**San Joaquin Solar (08-AFC-12)
Data Request Workshop Action Items Response**

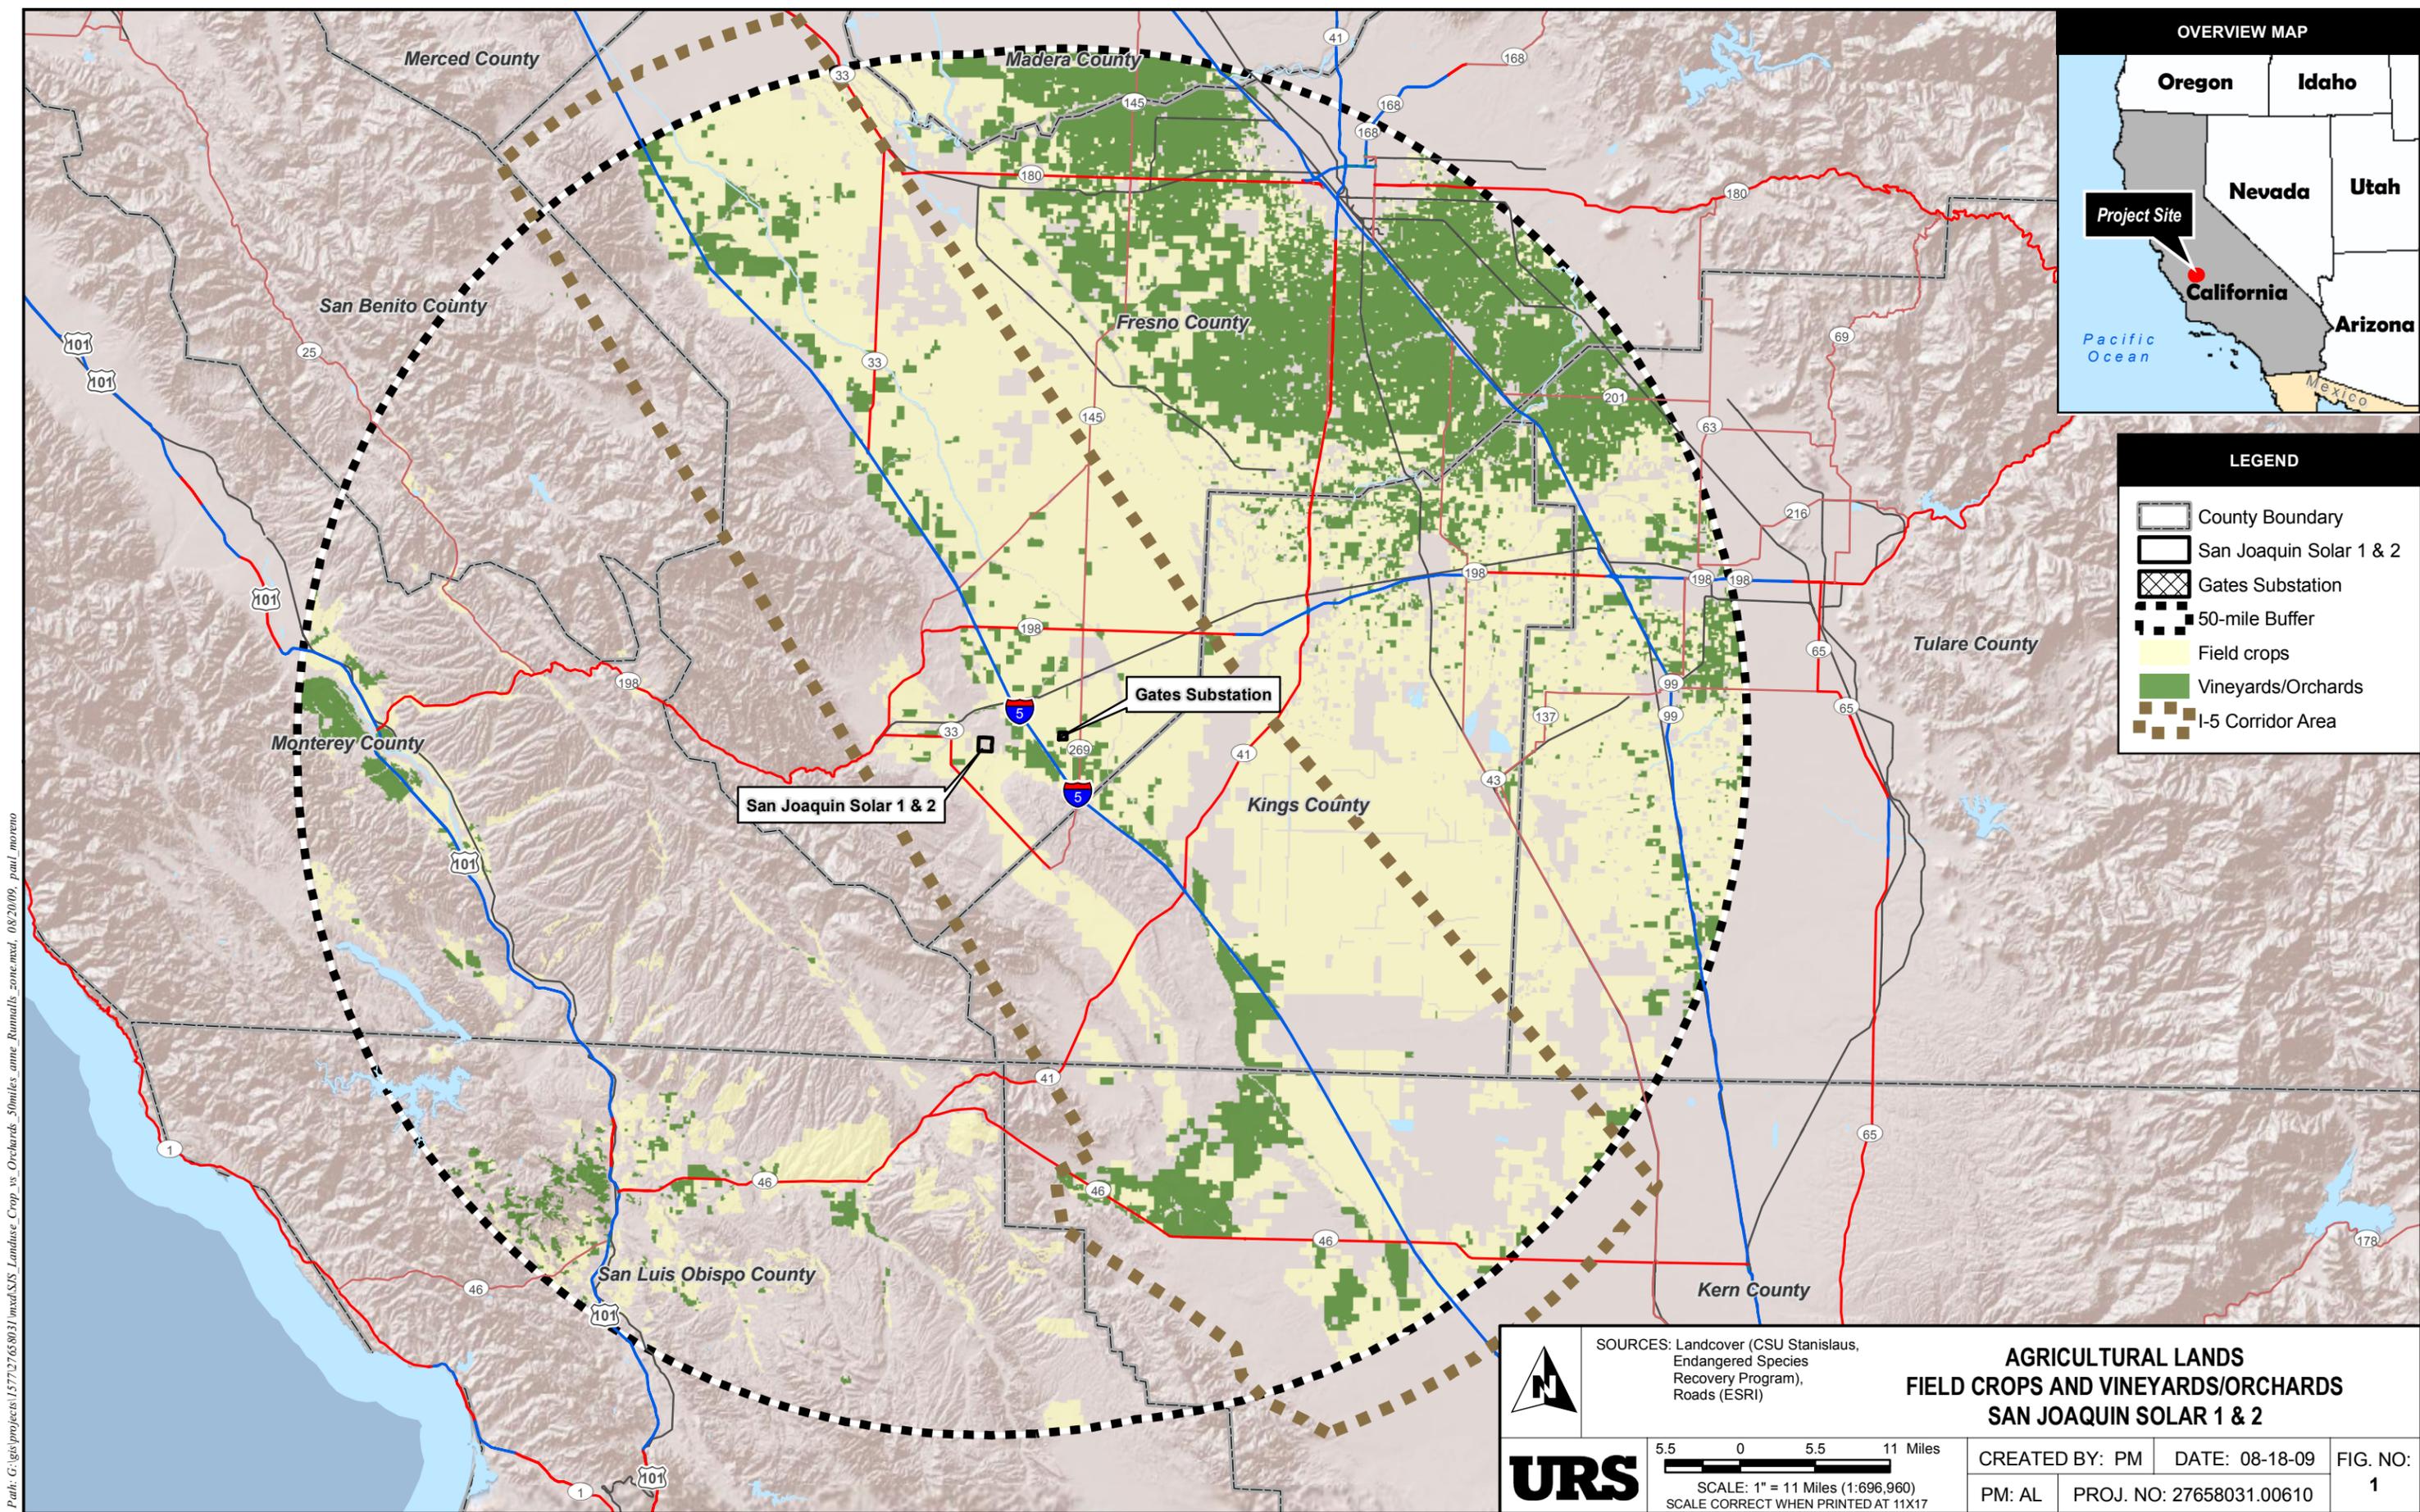
| Discipline Area | Action Item | Status |
|-----------------|---|---|
| Air Quality | Prepare a figure (land use map) with crop distribution or type to confirm the delivery distance and provide to CEC. | The attached Figure 1 presents the acreage of vineyards and orchards within a 50 mile radius of the Project in green. While the majority of the biomass fuel sources are located in the eastern portion of this area, there are over 135,000 acres of orchards and vineyards along the I-5 corridor within 50 miles of the plant which potentially produce an average of five million bone dry tons of biomass waste annually. This amount is more than ten times the total fuel requirements of SJS 1&2. This supports our expectation that the average one-way delivery distance of agricultural biomass will be 35 miles. |

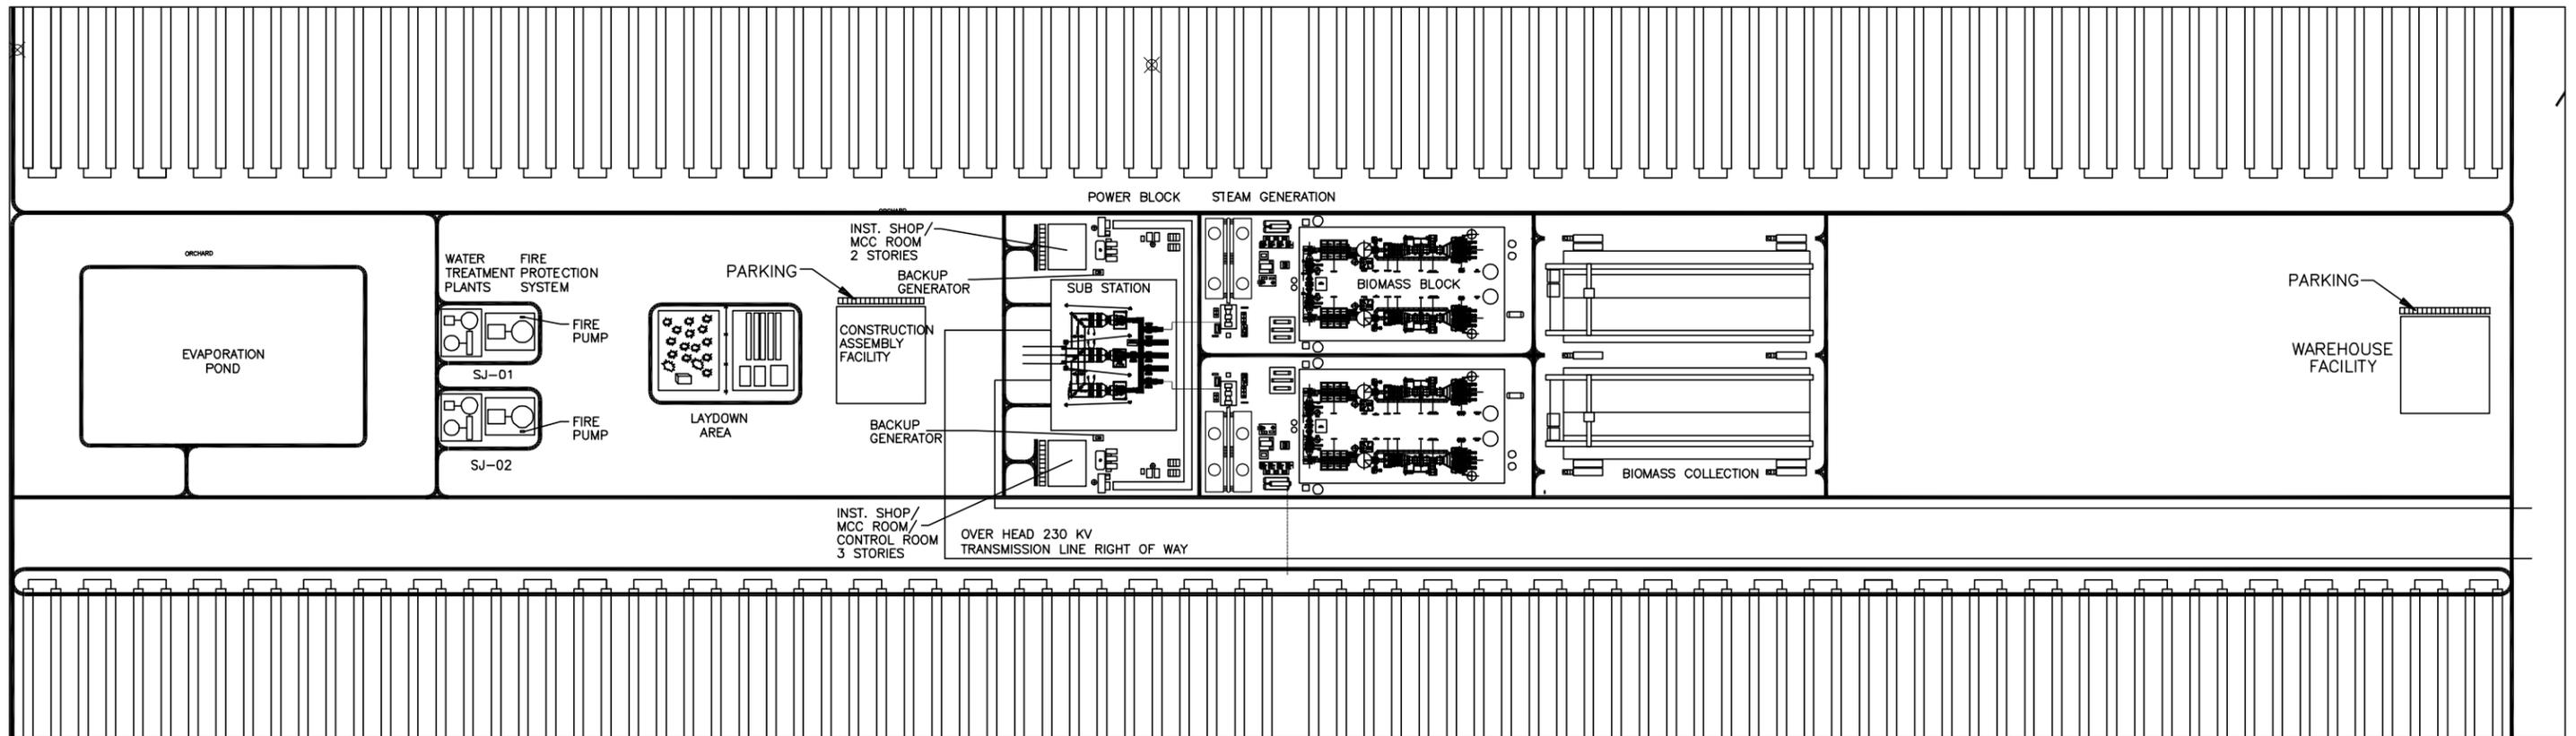
| Discipline Area | Action Item | Status |
|-----------------|---|---|
| Air Quality | Provide the latest WSAC TDS, cycles and associated PM emissions. | The TDS content of the make-up water for the WSAC presented in the AFC was determined from an onsite well. Grey water from the Coalinga waste water treatment center will also be used for make-up water in the WSAC. Recent data have been obtained that identify that the resulting mixed stream from these water sources, after being treated onsite, will contain a TDS of as high as 1850 ppm. The SJS1&2 water treatment facility will remove most of the hardness from the water and ensure a TDS content of no more than 1850 ppm. The particulate matter emissions from the WSACs have been revised to incorporate the maximum TDS level of 1850 ppm expected in the make-up water, 5 cycles of concentration, a slightly higher daily maximum circulating water rate, and a reduced drift rate due to a stricter eliminator control of 0.0002%. Particulate emissions from all WSACs associated with SJS1&2 were estimated to be 15.9 lb/day and 2.5 ton/year. The attached Table 1 presents these revised emissions and the data integral to these calculations. |

Note: Drift Eliminator Control guaranteed by Chuck Marchetta of Niagara Blower, Wet Surface Air Cooler Division

(REVISED) SITE PLAN
SAN JOAQUIN SOLAR 1 & 2

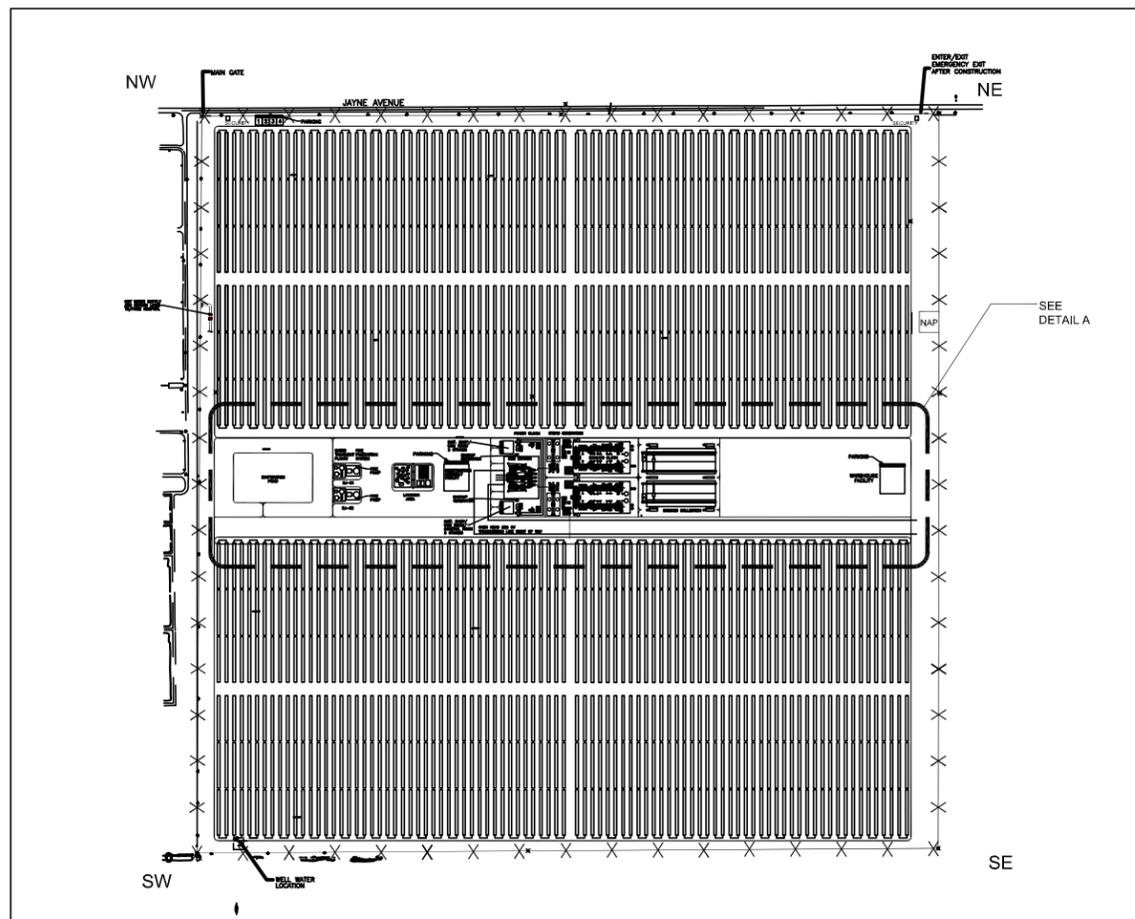
| Discipline Area | Action Item | Status |
|------------------|---|---|
| Haz Mat handling | Identify the storage location and manner for the HTF impacted soil. | The HTF impacted soil will be temporarily stored within a laydown area shown on the revised Figure 5.2-2 in Detail A (previously provided in the Response to Data Request and also attached). The temporary storage area will include a concrete slab with eight foot concrete walls on three sides. Impacted soil will be stored in this containment area until it is transported to an approved disposal facility. |
